## V2500-A1/A5 SERIES PROPULSION SYSTEMS SERVICE BULLETIN

This document transmits Revision 1 to Service Bulletin V2500-NAC-71-0306

# V2500-NAC-71-0306

NACELLE – POWER PLANT – REPLACEMENT OF THE FAN COWL DOOR CORNER PIECES**1. Planning Information****A. Effectivity****(1) Airplane:**

Replacement of the Fan Cowl Door Corner Pieces  
Figure 1 sheet 1

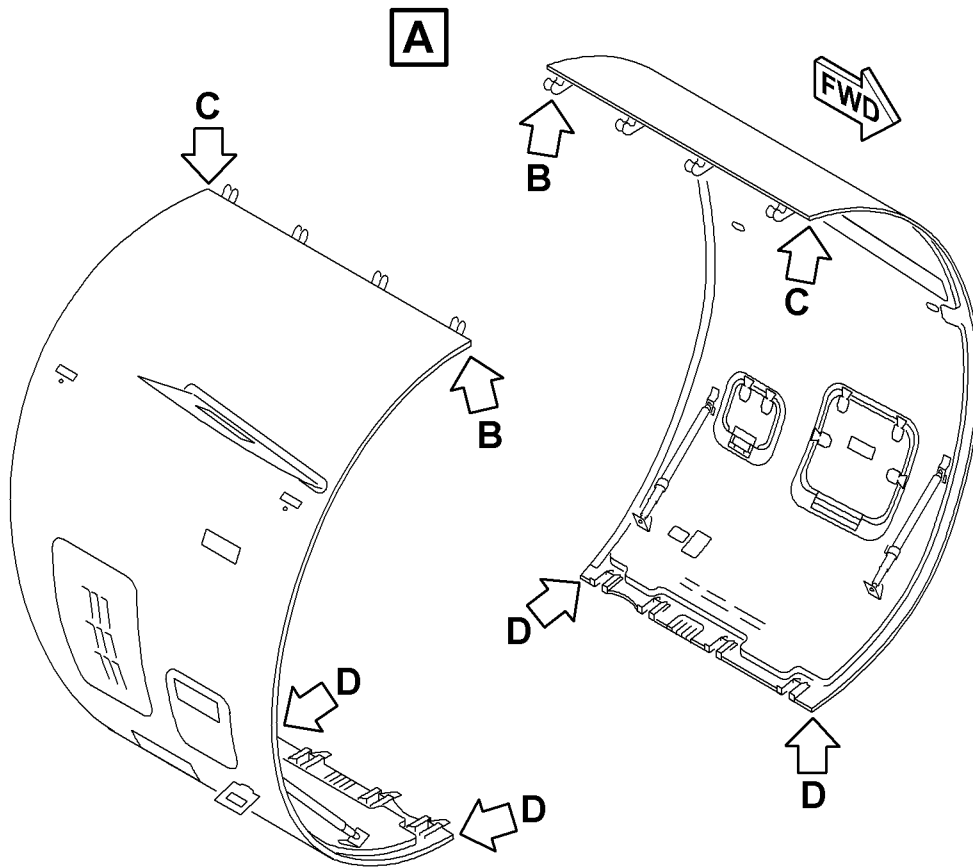
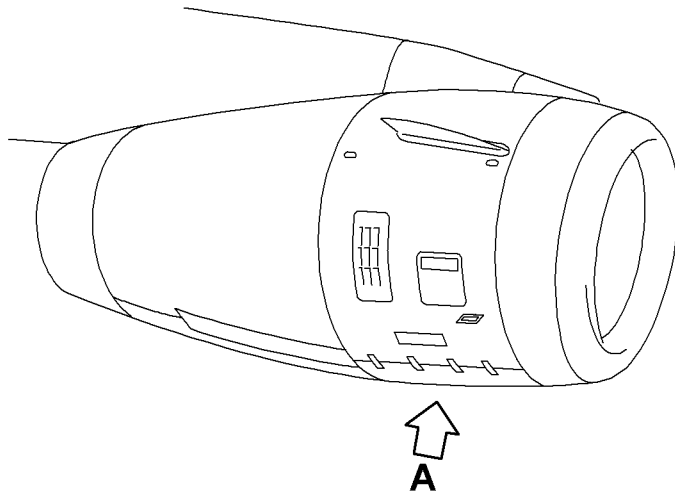
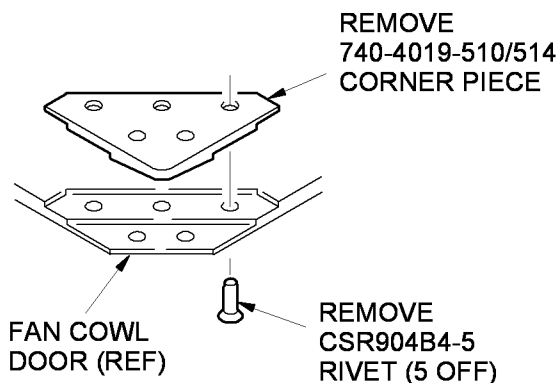
The Fan Cowl Door Corner Pieces are attached to the Fan Cowl Door by way of titanium rivets. The titanium rivet heads may make contact with the aluminium Capping Straps on the Inlet Cowl and cause excessive wear.

The new Corner Pieces have been designed to remove contact between the titanium rivet head and the aluminium Capping Strap. The new design will restrict wear to the nylatron Corner Pieces only. The new stepped arrangement on the Corner Piece will provide a visual and measurable indication of the amount of wear that has occurred to the Corner Pieces.

- (1) At four locations, carefully drill out the five rivets, P/N CSR904B4-5 to release the Corner Piece, P/N 740-4019 from the left hand Fan Cowl Door. Refer to Figure 1.
- (2) Remove the four Corner Pieces, P/N 740-4019 from the Fan Cowl Door.
- (3) At four locations, carefully drill out the five rivets, P/N CSR904B4-5 to release the Corner Piece, P/N 740-4019 from the right hand Fan Cowl Door.
- (4) Remove the four Corner Pieces, P/N 740-4019 from the Fan Cowl Door.
- (5) On the left hand Fan Cowl Door do the steps that follow.

- (a) At four locations, increase the size of the two fastener holes on the Fan Cowl Door to suit the rivet, P/N CSR904B5-5. Refer to the Standard Practices/Processes Manual, Task 70-39-03-390-501.
- (b) Remove any burrs from the Fan Cowl Door.
- (c) At four locations, apply masking tape (CoMat 02-178) on the outer surface of the Fan Cowl Door over the three redundant holes.

(n) At four locations, install the new Corner Piece, P/N 740-4019 to the Fan Cowl Door with the two rivets, P/N CSR904B5-5 as instructed in the Standard Practices and Processes Manual, Task 70-39-03-390-501 with jointing compound (CoMat 04-005).

Replacement of the Fan Cowl Door Corner Pieces  
Figure 1 sheet 2

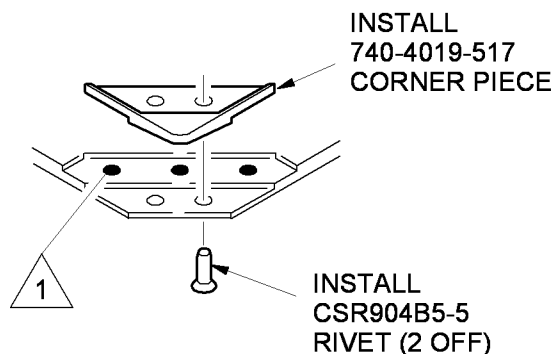
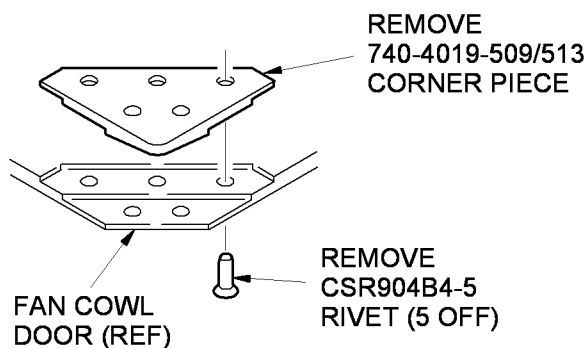
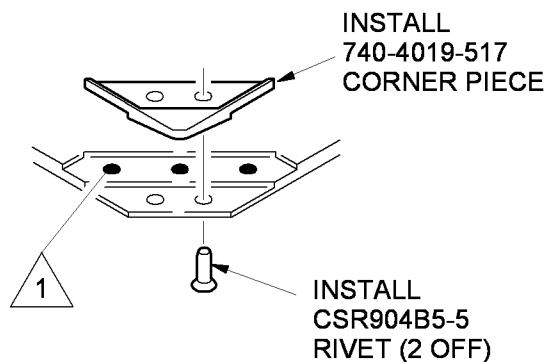
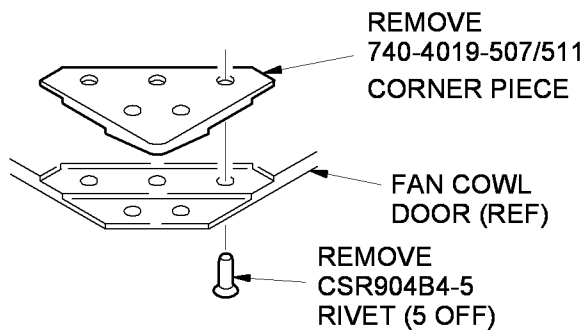
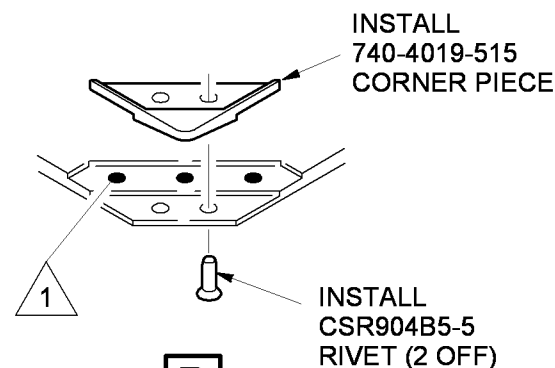
**B**  
BEFORE

**B**  
AFTER

**C**  
BEFORE

**C**  
AFTER

**D**  
BEFORE

**D**  
AFTER

**NOTE:**  
FILL VACANT FASTENER HOLES  
WITH SCOTCH-WELD 2216 B/A ADHESIVE.
